Identification cards — Test methods —

Part 1:

General characteristics

AMENDMENT 1

Figure Amd.1-1 — ICC-holder

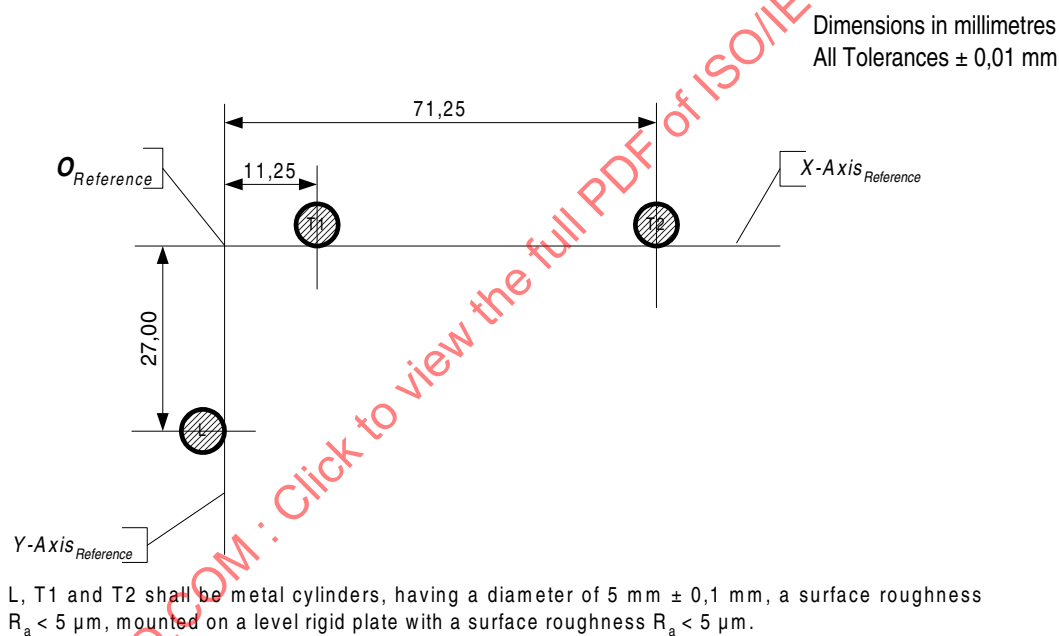
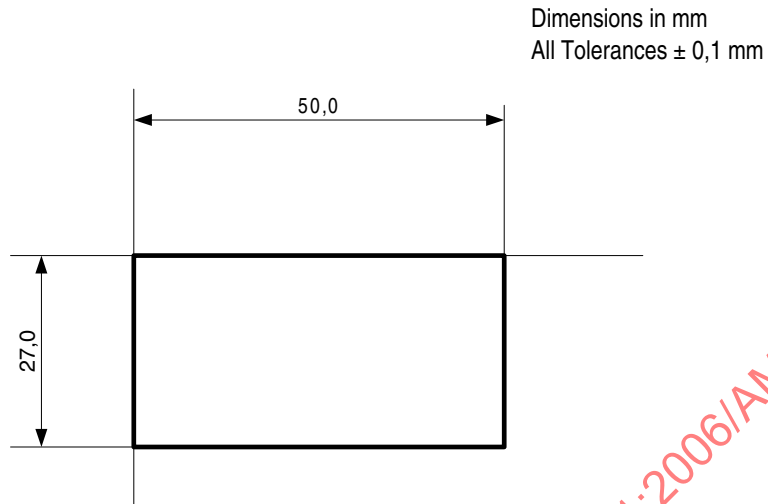
The default measurement position requires the ICC to be positioned in an ICC-holder and flattened by a flattening plate. All Measurements using this default measurement position shall be relative to the reference axes defined in Figure Amd.1-1.

The default ICC holder shall comply with Figure Amd.1-1:

Figure Amd.1-2 — Flattening plate

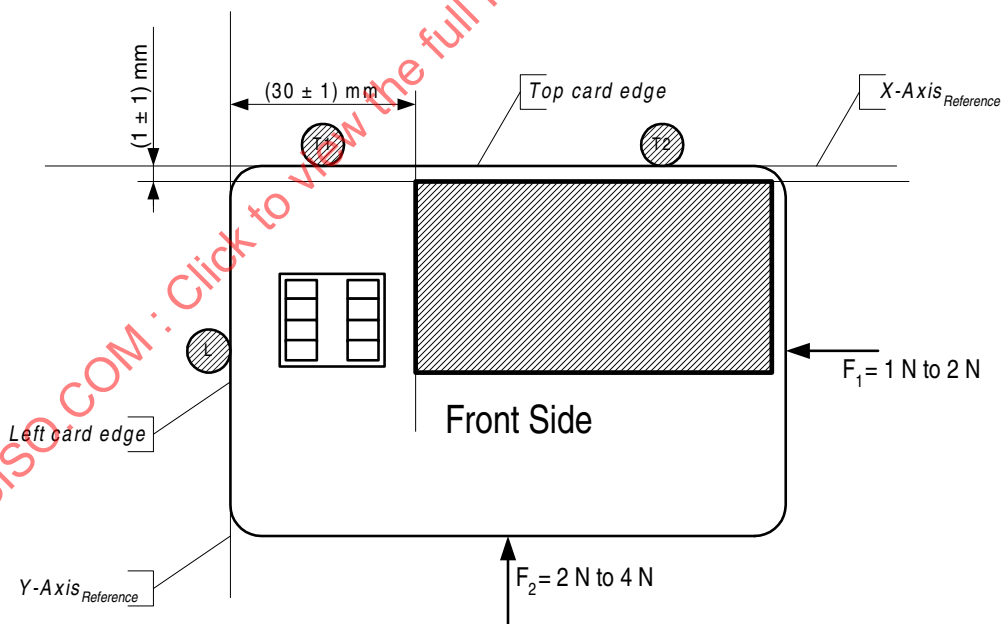
The flattening plate shall comply with Figure Amd.1-2:

The surface roughness of the flattening plate shall be $R_a < 5 \mu\text{m}$.

Figure Amd.1-4 — ESD test circuit

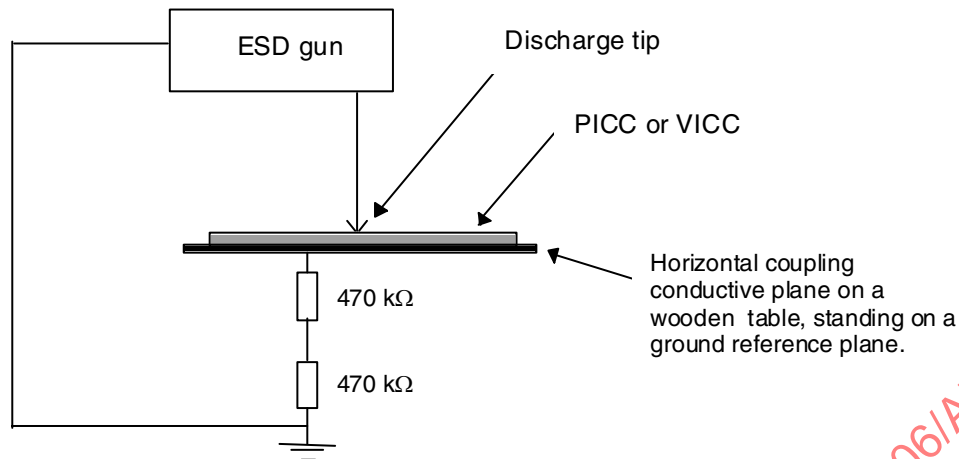
Connect the ground pin of the apparatus to the conductive plate upon which the PICC or VIVV is placed (see Figure Amd.1-4).

Figure Amd.1-5 — Test zones on PICC or VICC for ESD test

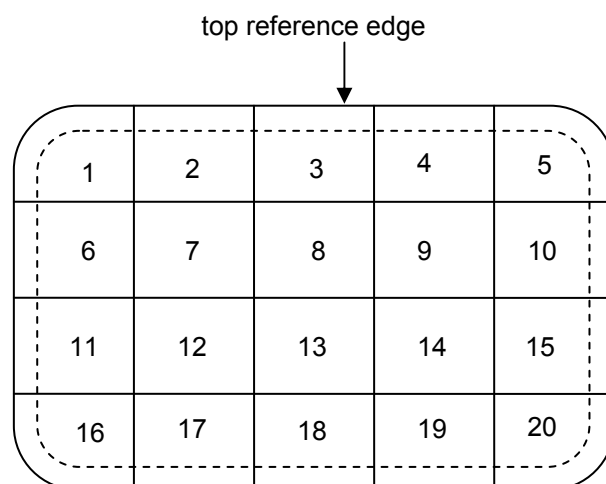
Apply the discharge successively in normal polarity to each of the 20 test zones shown in Figure Amd.1-5 ensuring that the discharge tip is not applied within 6 mm of the card perimeter (see the dashed boundary line in Figure Amd.1-5) and allowing a cool-down period between successive pulses of at least 10 s.

WARNING — If the PICC or VICC includes contacts, the contacts shall face up and the zone which includes contacts shall not be exposed to this discharge.

Figure Amd.1-6 — Test prods

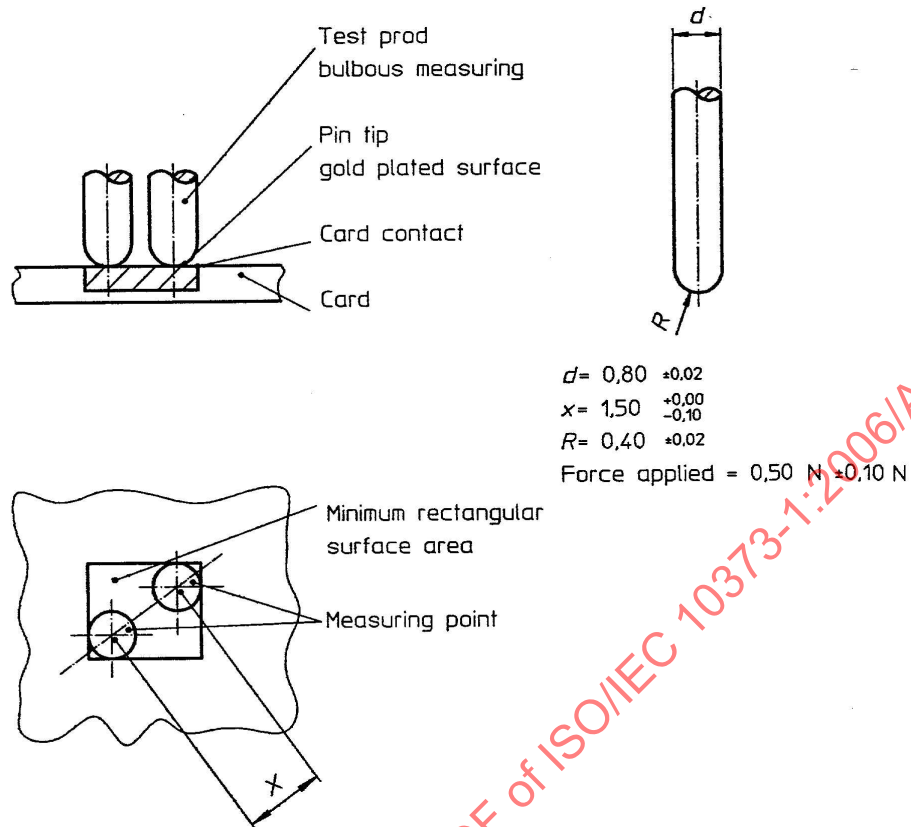
Ohmmeter with a range from 10 mΩ to 2 Ω having an accuracy of ± 2 mΩ and test prods as defined in Figure Amd.1-6. The measurement current shall be less than or equal to 100 mA and the measurement voltage shall be less than or equal to 20 mV.

Figure Amd.1-7 — Measurement tip

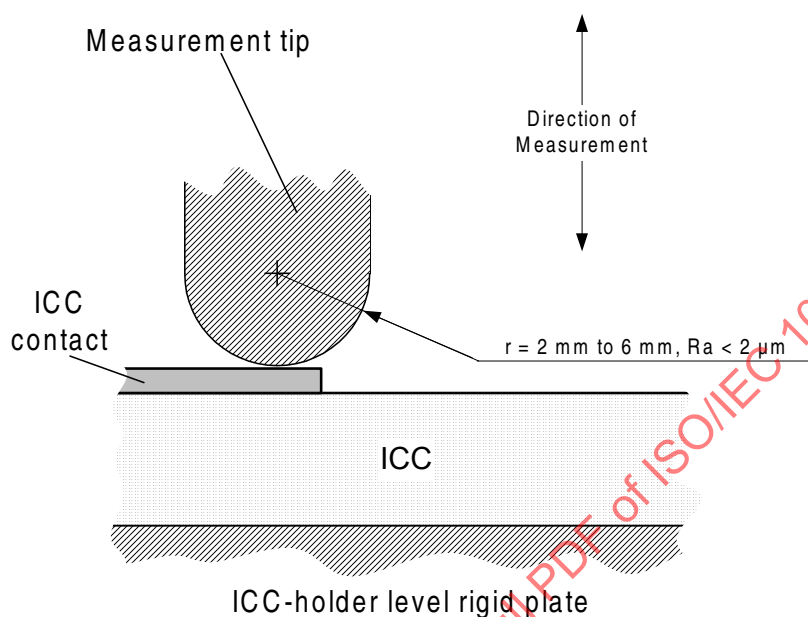
A measurement device capable of measuring the perpendicular distance between the upper surface of the level rigid plate of the ICC-holder and the upper surface of an ICC placed on the ICC-holder with an accuracy of 0,01 mm. The area of measurement shall be 2,5 mm wider in all directions than the area covered by the contact metallization of the ICC to be tested. The measurement tip shall be as shown in Figure Amd.1-7:

Figure Amd.1-8 — Measurement line across contacts C1 and C5

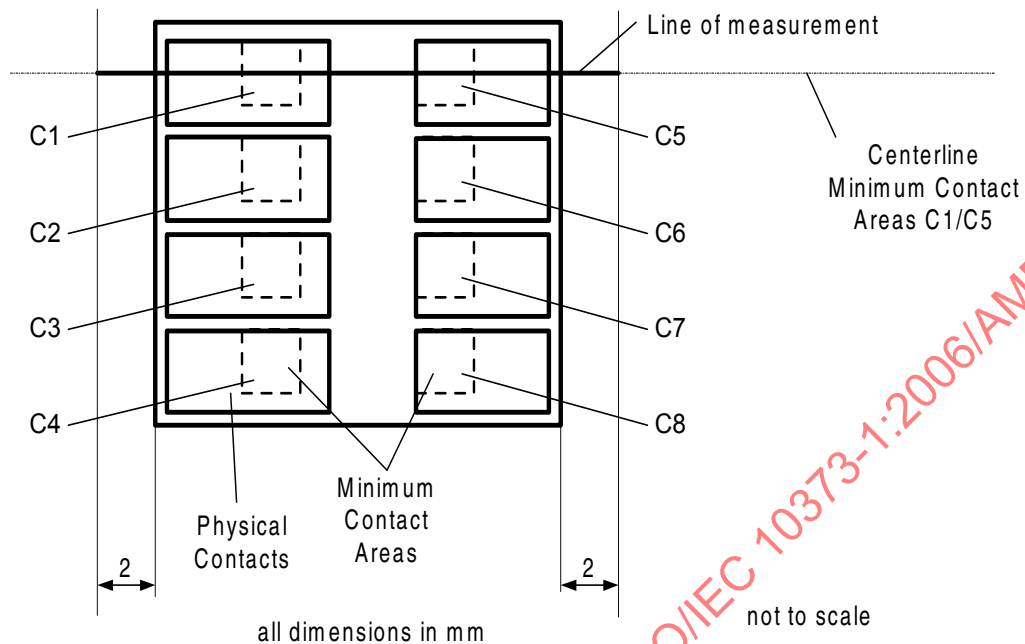
- Mount the ICC in the default measurement position as defined in 4.6.1.
- Construct a measurement line on the surface of the ICC along the centerline of the minimum contact areas C1 and C5, beginning and ending at a distance of 2 mm of the metallized contact surface (Figure Amd.1-8).

Figure Amd.1-9 — 3 wheel test principle

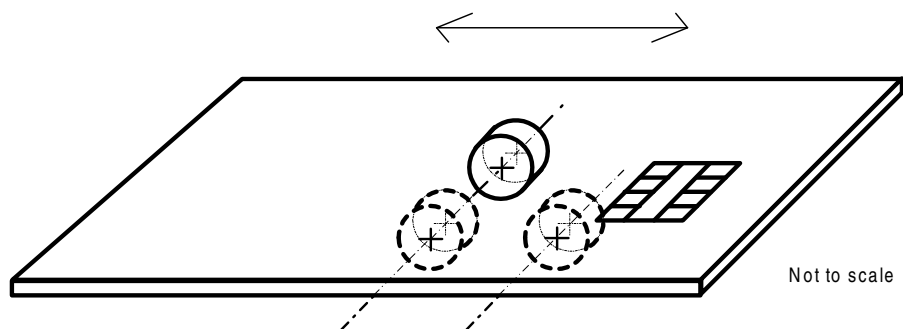
The principle of the apparatus is shown in Figure Amd.1-9. It comprises three wheels, one above and two below the ICC. The ICC is moved cyclically between the three wheels, so that the contact area is repeatedly exposed to the forces exerted by the wheels.
